Preliminary Consultation
MONTGOMERY COUNTY HISTORIC PRESERVATION COMMISSION
STAFF REPORT

Address:	15911 Redland Road, Derwood	Meeting Date:	6/26/2024
Resource:	Master Plan Site #22/03-003A <i>Derwood Store and Post Office</i>	Report Date:	6/18/2024
Applicant:	CLW Real Estate Group (Lawrence Smith, Agent)	Public Notice:	6/12/2024
Review:	Preliminary Consultation	Staff:	Dan Bruechert
Proposal:	Siding and Window Replacement, and Porch Rehabilitation

Figure 3: Proposed west elevation.

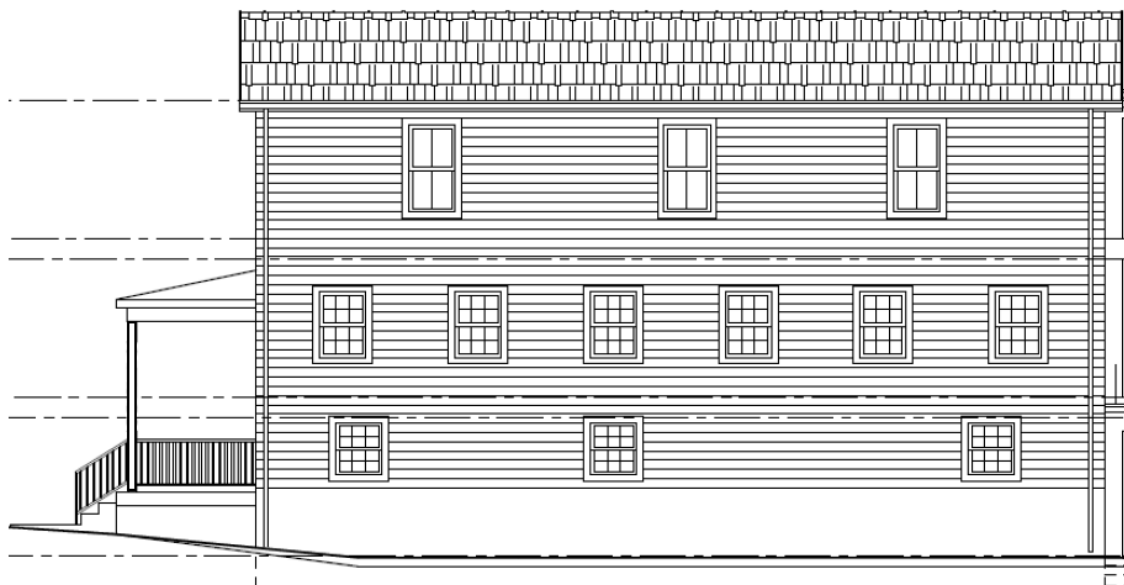
Staff requests the applicant to clarify what is identified in the submitted drawings as the ‘West Elevation’ (Staff believes the drawings are mislabeled and should be identified as the East elevation), because the arrangement of the window openings does not appear to be consistent with the floorplans submitted in the previous Preliminary Consultation. Staff requests the applicant submit an accurate drawing of the west elevation with the HAWP application.

Staff has two concerns regarding the east elevation. First, Staff is unsure whether the proposal is intended to be illustrative or if the proposal has been revised from the version presented in 2022. Staff does not find the revised fenestration proposed (see *Figure 5*, below) to be appropriate and recommends the applicant proceed with the earlier proposal. Because floor plans were not presented with this submission, Staff cannot provide more analysis than to say the paired sash windows are incompatible with the 1904 vernacular architecture and need to be revised.

Staff’s second concern on the east elevation is the applicant’s proposal to enlarge the two basement window openings on the east elevation to satisfy egress requirements to be appropriate. Staff finds retaining the window opening size and installing a casement window in these openings would be preferable to enlarging the opening and installing a larger sash window.

Figure 6: Undated photo showing the Derwood Store and Post office before the porch was enclosed.

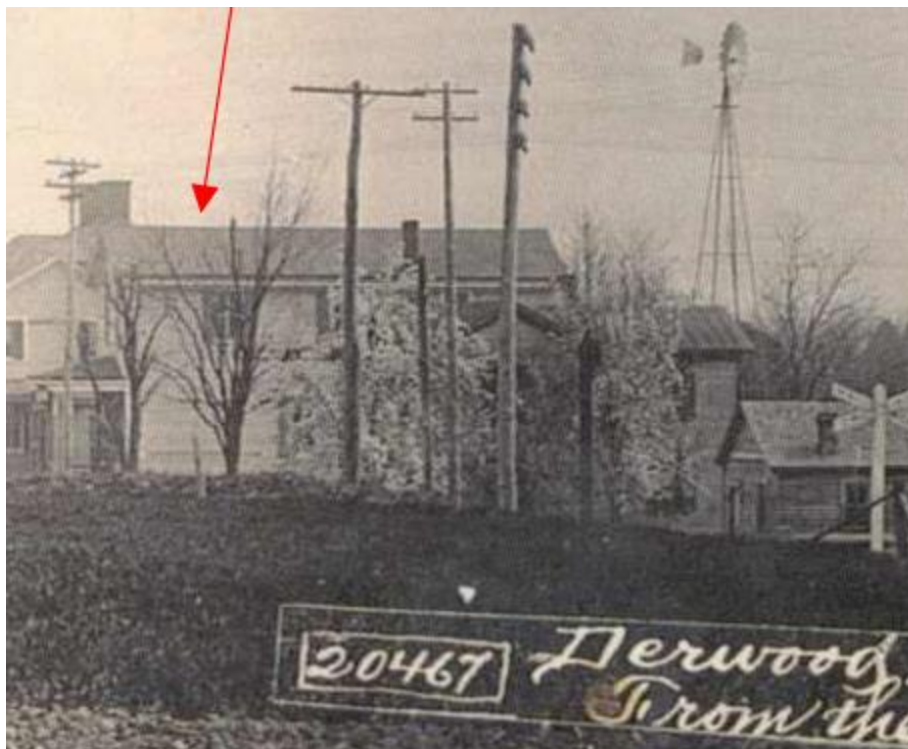
Staff finds the simple design and materials of the porch are all compatible with the Derwood Store and Post Office's early 20th-century commercial architecture. Examples of similar types of buildings were included as context in the Master Plan Amendment including the Darby Store in Beallsville and Poole's Store in Seneca.

Staff additionally finds the materials, primarily wood, are compatible with the character of the building. Staff notes that many of the wood members will be pressure-treated wood. Staff recommends the applicant wait six months before applying stain or paint on the porch to allow the wood to dry and for the paint to properly adhere.

- The appropriateness of the porch design;
- The appropriateness of the proposed porch materials; and
- Any other recommendations.
